Rotary
Service Bulletin
Index

Bulletin No. RE-1
 Date DECEMBER 20, 1974
 Page 1 of 3

SUBJECT: RE5 INTRODUCTORY NOTES
 Affected Models: _____
 Effective Engine No.: _____
 Reference: _____

BATTERY VENT TUBE:

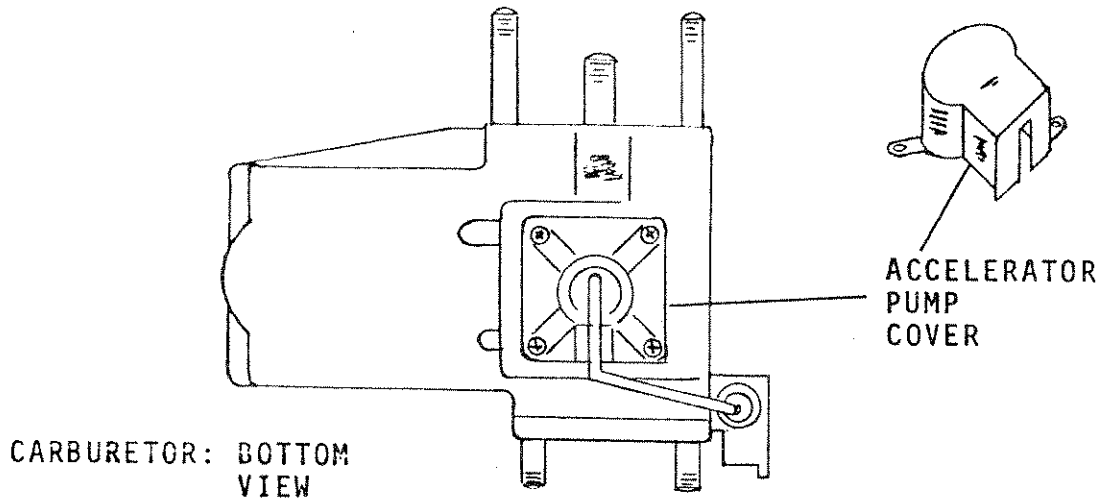
All RE5's are specially equipped with a rubber battery vent tube located under the right frame cover.

During pre-delivery service of RE5's, the original plastic battery vent tube is to be removed and replaced with the rubber vent tube. The rubber vent tube is pre-routed to prevent the possibility of battery fluid overflow, from contacting and damaging any component parts. Therefore, it should not be removed. If it is removed for any reason, be sure it is re-routed according to the illustration located on the rear fender, under the seat.

The battery vent tube clamp on the battery holder plate should not be used.

ADVANCE INDICATOR LINES

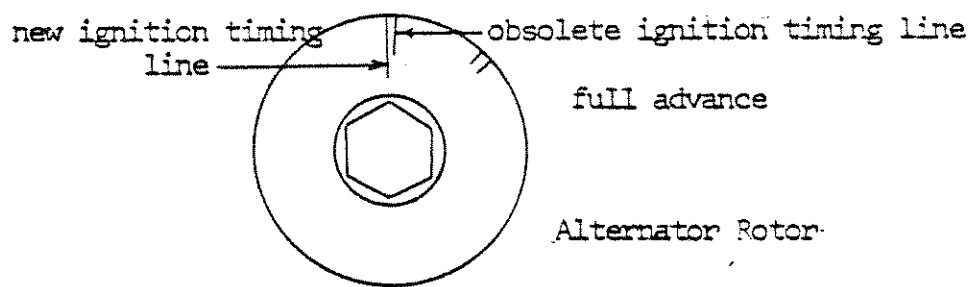
Please note that the ignition timing and its advance characteristic in the production type RE-5 are explained as follows:

- * IGNITION TIMING 5 degree B.T.D.C. at idling speed.
- * TIMING ADVANCE CHARACTERISTIC

When checking the ignition timing advance, use the longest line shown in the illustration for setting the pointer wire to it referring to the idling ignition timing; the line next to it (obsolete line) will give 4 degrees difference from the specification.

PAGE	TO BE CORRECTED	CORRECT TO
74	(SPECIFICATION) Start-of-advance speed <u>1400 rpm</u> Full-advance speed <u>5000 rpm</u> Advance angle $22^{\circ} \pm 1^{\circ}$	1800 rpm 5800 rpm $26^{\circ} \pm 1^{\circ}$
79	(6th line from the top) notch marked "11" (7th and 8th lines from the top) <u>The weight spring may be hooked to either weight.</u>	"13" delete
150	(Second paragraph) It should be 10° BTDC (3rd paragraph) the specification (10° BTDC) (last paragraph) all the way to upwards of <u>5000 rpm</u> starts advancing at about <u>1400 rpm</u> when <u>the level of 5000 rpm</u> no further advance for speeds above <u>5000 rpm</u>	5° 5° 5800 rpm 1800 rpm more than 5800 rpm 5800 rpm

Please alter the illustration "Fig 8-4 C.D. Unit check circuit" in the page 76 as shown below.

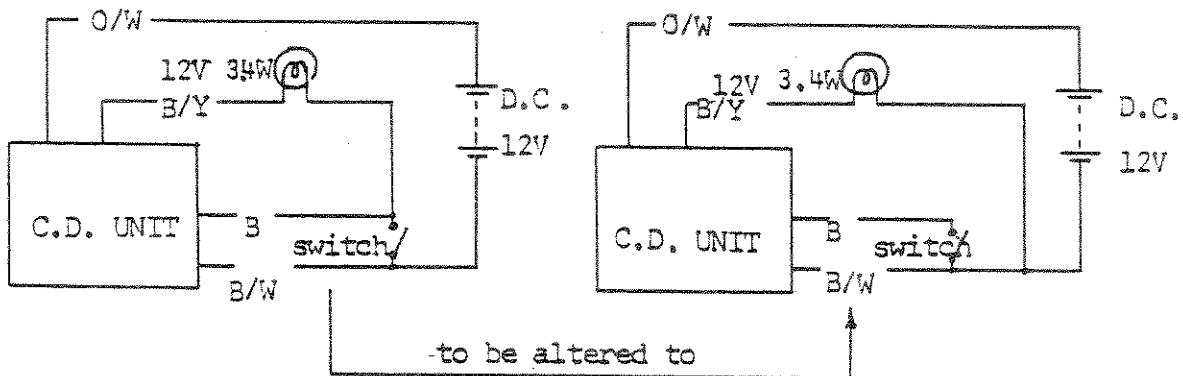
The existing check circuit in the manual can still be operable and the lamp lights as good as the altered circuit shown above. This operation, however, may damage the element inside the C.D. unit; whereas the altered one does no harm.

ADDITIONAL INFORMATION

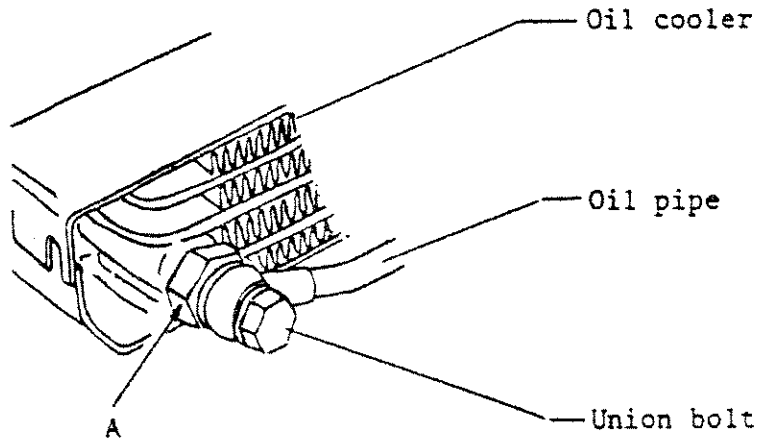
This is intended to call your attention to a proper procedure to tighten the oil pipe joint at the oil cooler on the model RE5.

Please be sure to hold the indicated "A" securely with a wrench when tightening the union bolt. Tightening the union bolt with part "A" unrestrained applies undue stress to the oil cooler which may result in damage.

Damage of the oil cooler can also result in serious damage to the engine. Therefore, please follow the above instructions whenever tightening the oil pipe.

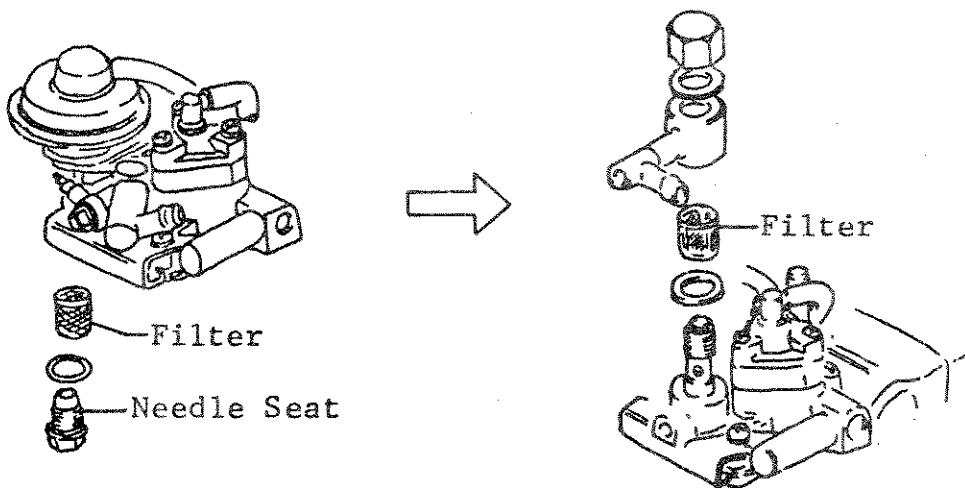
I. PROBLEM:

Carburetor fuel filter blockage with foreign particles.

CAUSE:

In the process of manufacturing the fuel tank, some very fine particles adhere to the inside surface. These particles are loosened by the initial fuel filling and flow to the carburetor, where they are caught by the filter.

All fuel tanks are now washed out prior to assembly and the filter mesh has been modified from #200 mesh to #120 mesh. The #120 mesh is coarser.

This modification has been incorporated from and including engine number RE5-10547.

PART NAME	PART NUMBER		AVAILABILITY
	OLD	NEW	
VALVE SEAT FILTER	13376-37010	13376-37012	NEW TYPE ONLY

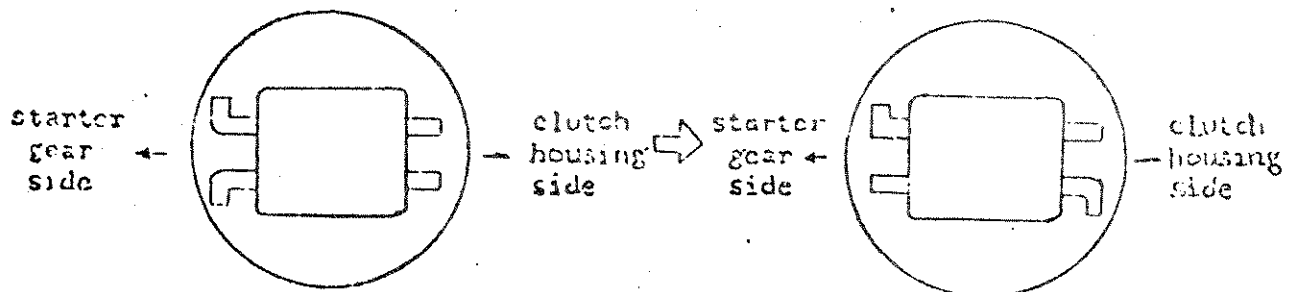
The new style one-way starter clutch and thrust washer has been installed on RE5's, on and after ENGINE NUMBER RE5-12054.

1. When replacing the old style one-way starter clutch assembly with a new style starter clutch, a new style washer must be used. If an old style washer is used, the starter clutch will slip.
2. There is an identical old style washer on the other side of the primary driven gear. It should also be replaced with a new style washer to prevent accidentally interchanging it with the starter clutch thrust washer during reassembly.
3. The old style clutch can be used with the new style washers.
4. Correct figure 10-15, page 99 of the RE5 Service Manual as indicated below:

DESCRIPTION	OLD PART NO.	INTER-CHANGE	NEW PART NO.
One-way clutch Ass'y	12650-37021	←○→ →○←	12650-37022
Washer	09160-26002	←○→ →X←	09160-26005

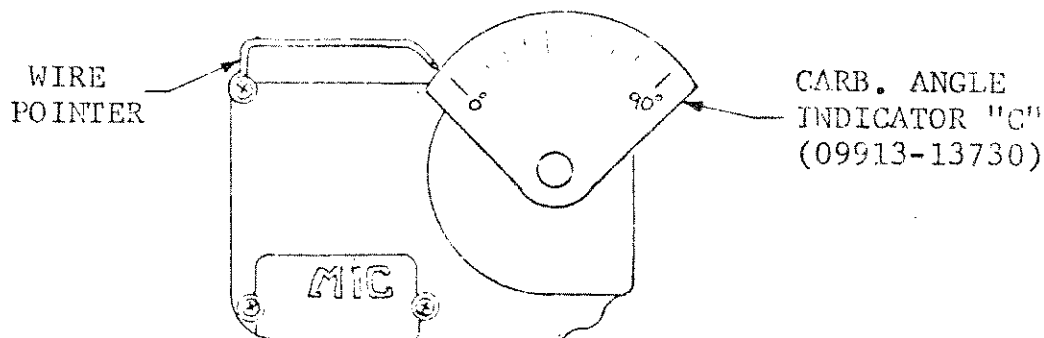
Information has been received by U. S. Suzuki which indicates that some RE5M's are experiencing carburetion difficulties in very warm weather. This may vary from a light popping sound in the mufflers to a surging or jerking feeling when cruising, especially in lower gears.

There have also been some reports of a hesitation or "stumbling" when leaving from a stop, accelerating, or when shifting gears.

To correct these conditions U. S. Suzuki will supply a Carburetor Modification Kit to be installed on all RE5M's.

1. Remove Carburetor:
 - a. Disconnect fuel level switch connector, petcock vacuum line and fuel line, release rear fuel tank strap, and remove fuel tank.
 - b. Loosen air filter intake hose clamp, slide hose off carburetor inlet air horn and tuck it behind the upper frame tube.

- c. Remove the carburetor air intake horn held by the three (3) acorn nuts.
 - d. Remove the carburetor nuts and washers. This can be accomplished by using a 12mm twelve-point box end wrench from the left side or a 3/8" drive 12mm socket, universal joint, extension, and ratchet from the right side.

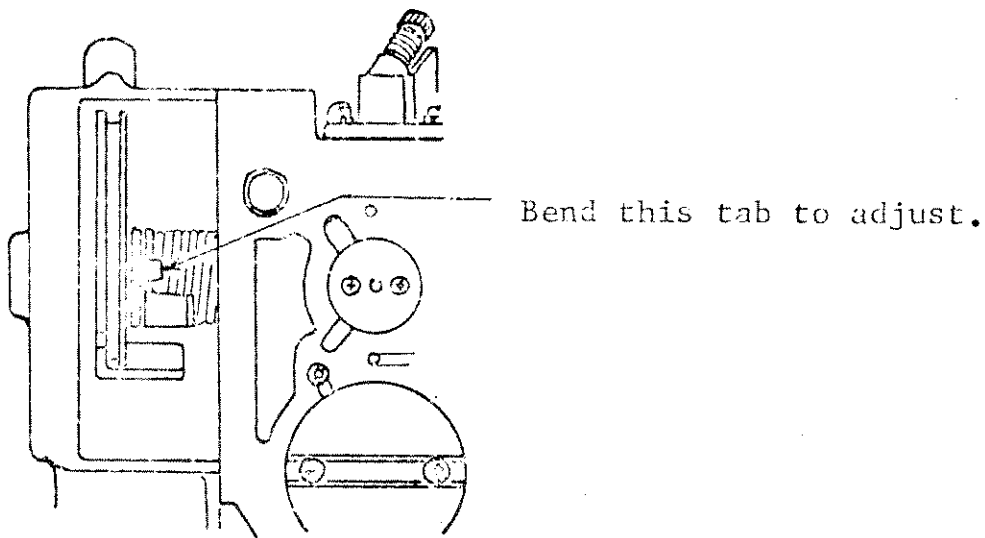
- e. Set the accelerator pump touch timing to 28°. That is with all of the play removed from the accelerator pump arm by lightly pulling down on the accelerator pump arm in the area of the rod, gently turn the throttle grip until the accelerator pump arm just begins to move.

- f. If the accelerator pump timing is early or late, adjust it by bending the brass colored tab next to the carburetor cable pulley.

NOTE: Be carefully when bending the tab that you do not warp the arm and cause it to bind on the primary throttle shaft.

SUBJECT: RE5 SPARK PLUG INSTALLATION

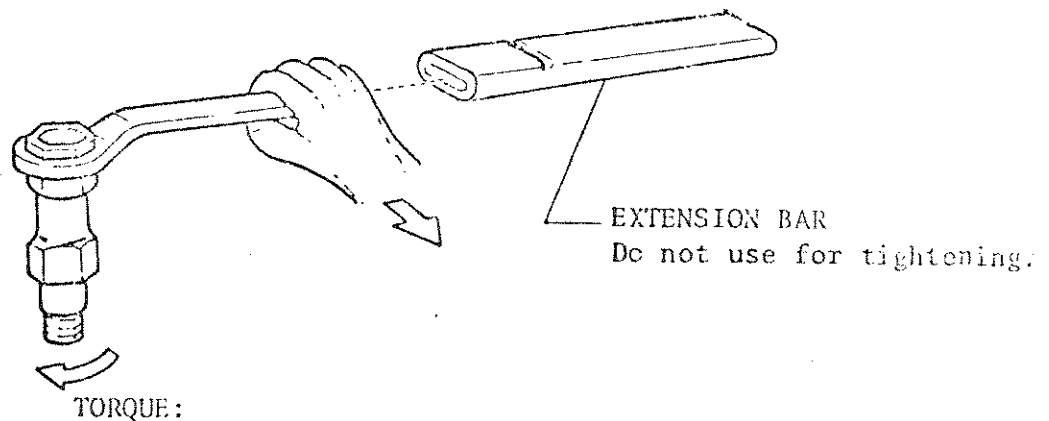
The RE5 spark plug is a taper seat design and does not require a gasket. Taper seat spark plugs require extra care when they are installed, to be sure they are not over tightened.

TORQUE TO: 18 ft-lb

CAUTION: When the engine is hot the spark plug may be difficult to remove. DO NOT use the extension bar or use force to loosen the spark plug. Allowing the engine to cool will ease removal of the spark plug.
